From: David King <[REDACTED]>
Sent: Monday, October 20, 2014 3:16 PM
To: Guernsey, Greg
Cc: Camou, Juan; gardner sumner
Subject: 2015 Goodrich Avenue - Appeal Issuance of Building Permit - 2014-093888 PR
Attachments: 2015 Goodrich Avenue - Appeal.pdf; 2015 Goodrich appeal reasons.doc

2015 Goodrich Ave (Permit Number 2014-093888 PR)

**CITY OF AUSTIN APPLICATION TO BOARD
OF ADJUSTMENT INTERPRETATIONS
PART I: APPLICANT'S STATEMENT
(Please type)**

Planning and Development Review Department interpretation is: Re: 2014-093888 PR

2015 GOODRICH AVENUE

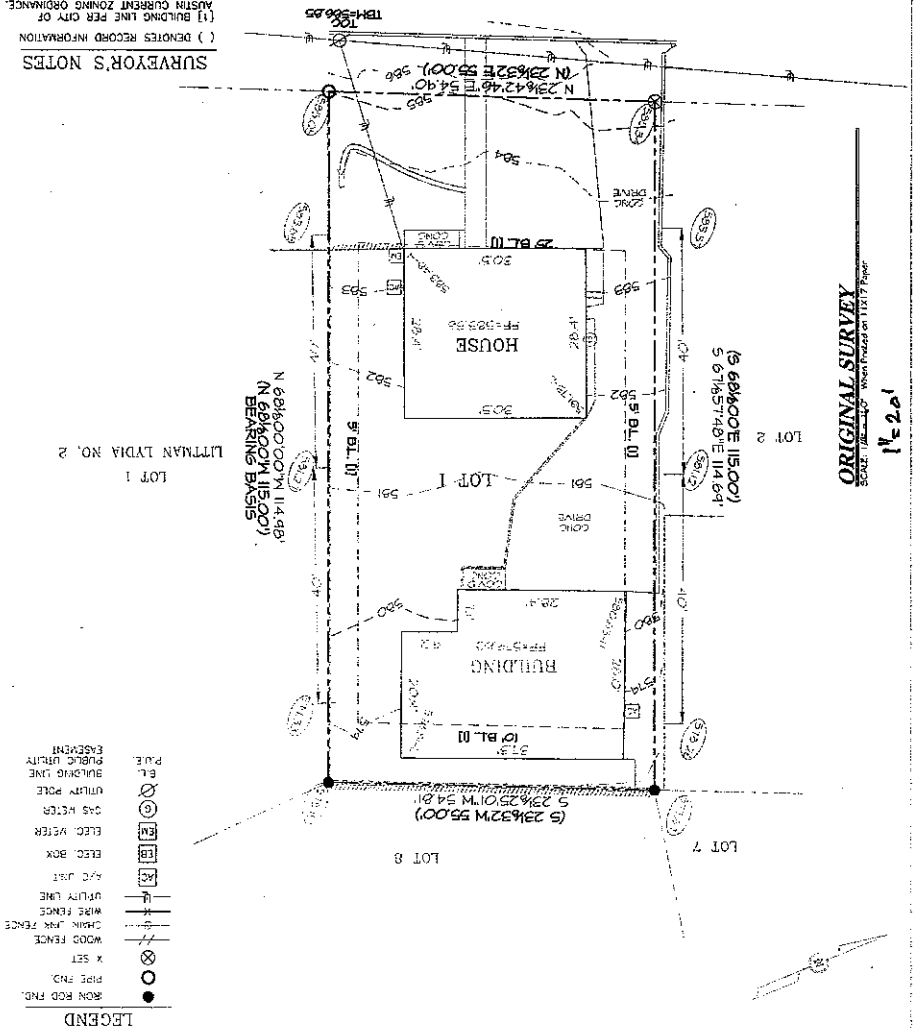
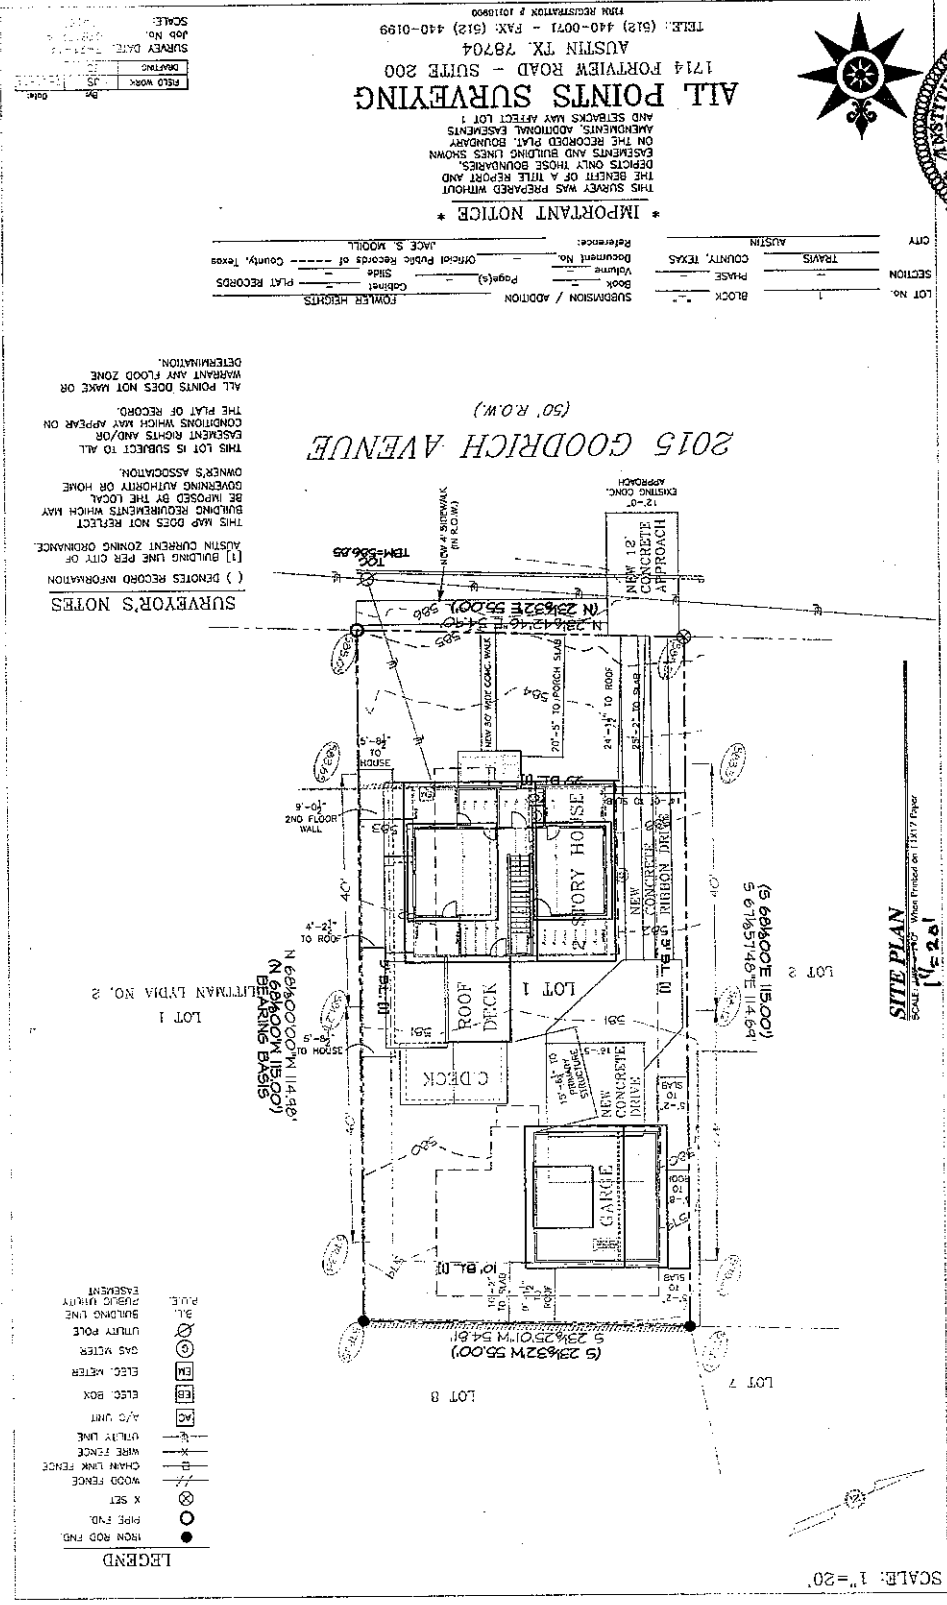
- 1) The applicant is using a lot size of 6,325 sq ft to make impervious cover and McMansion FAR calculations. This is the lot size shown at the Travis County Appraisal District (TCAD). However, the applicant presented an actual survey conducted by All Points Surveying on 21 Jul 2014. The property lines shown on this survey calculate to 6,296.6 sf. The surveyed area should be used since the TCAD areas are notoriously inaccurate. This will result in a higher impervious cover and McMansion FAR percentage.

- 1) The applicant is using a lot size of 6,325 sq ft to make impervious cover and McMansion FAR calculations. This is the lot size shown at the Travis County Appraisal District (TCAD). However, the applicant presented an actual survey conducted by All Points Surveying on 21 Jul 2014. The property lines shown on this survey calculate to 6,296.6 sf. The surveyed area should be used since the TCAD areas are notoriously inaccurate. This will result in a higher impervious cover and McMansion FAR percentage.

- 1) The permit shows a lot size of 6,325 sq ft to make impervious cover and McMansion FAR calculations. ~~This is the lot size shown at the Travis County Appraisal District (TCAD).~~

FIRST FLOOR PLAN
SCALE: 1/8" = 1'-0" When Printed on 24" x 36" Paper
SCALE: 1/8" = 1'-0" When Printed on 11" x 17" Paper

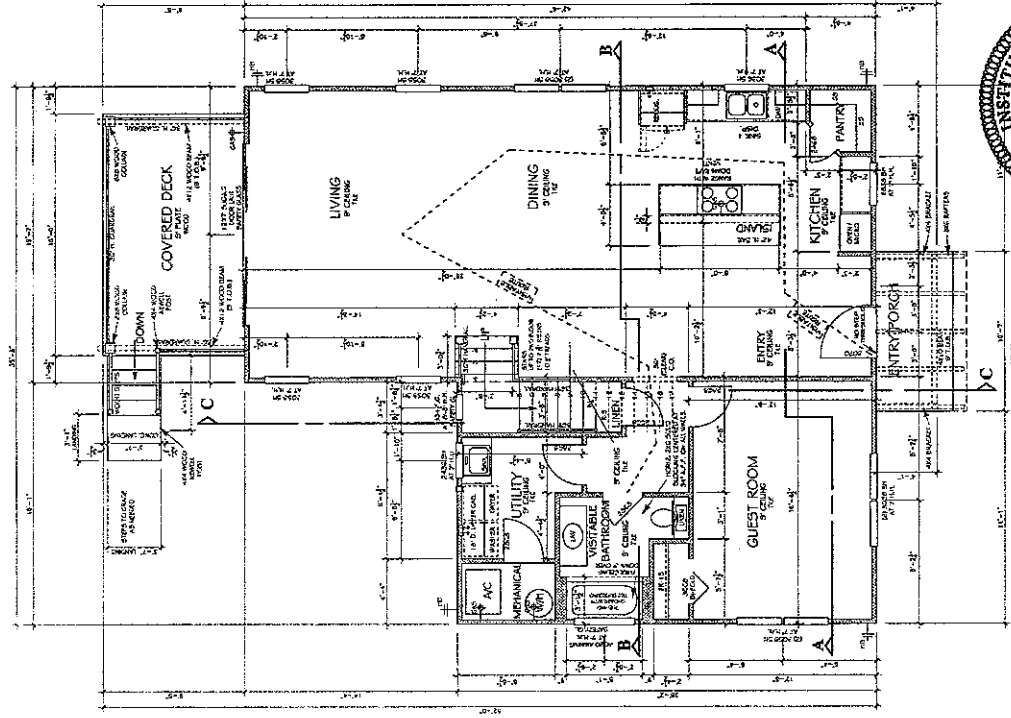
- 2) The architectural plans of the first and second floor (Drawings A1.1 and A1.2) appear to be drawn to the outer edge of the wood framing and not to the "outside surface of the exterior walls" demonstrated by the fact that the first floor plan dimensions (Drawing A1.1) match the foundation plan dimensions (Drawing S-1). Normally, the edge of the framing is aligned with the foundation edge. When sheathing and siding is added, this dimension can increase by an inch or more on all sides. Since the criteria for calculating the McMansion FAR is measurement to the "outside surface of the exterior walls", the McMansion FAR is not calculated correctly. If one assumes a ½" sheathing and ¾" siding, the first floor area is increased to 1,301.6 sf and the second floor area is increased to 1285.3 sf. This is an additional 33.8 sf that must be added to the McMansion FAR calculation.

- 2) The architectural plans of the first and second floor (Drawings A1.1 and A1.2) appear to be drawn to the outer edge of the wood framing and not to the "outside surface of the exterior walls" demonstrated by the fact that the first floor plan dimensions (Drawing A1.1) match the foundation plan dimensions (Drawing S-1). Normally, the edge of the framing is aligned with the foundation edge. When sheathing and siding is added, this dimension can increase by an inch or more on all sides. Since the criteria for calculating the McMansion FAR is measurement to the "outside surface of the exterior walls", the McMansion FAR is not calculated correctly. If one assumes a ½" sheathing and ¾" siding, the first floor area is increased to 1,301.6 sf and the second floor area is increased to 1285.3 sf. This is an additional 33.8 sf that must be added to the McMansion FAR calculation.

- 2) The architectural plans of the first and second floor (Drawings A1.1 and A1.2) are drawn to the outer edge of the wood framing and not to the outside surface of the exterior walls. demonstrated by the fact that the first floor plan dimensions of the building permit (Drawing A1.1) match the foundation plan dimensions (Drawing S-1). Normally, the edge of the framing is aligned with the foundation edge. When sheathing and siding is added, this dimension can increase by an inch or more on all sides. Since the criteria for calculating the McMansion FAR is measurement to the "outside surface of the exterior walls", the McMansion FAR is not calculated correctly. If one assumes a 1/2" sheathing and 3/4" siding, the first floor area is increased to 1,301.6 sf and the second floor area is increased to 1285.3 sf. This is an additional 33.8 sf that must be added to the McMansion FAR calculation.
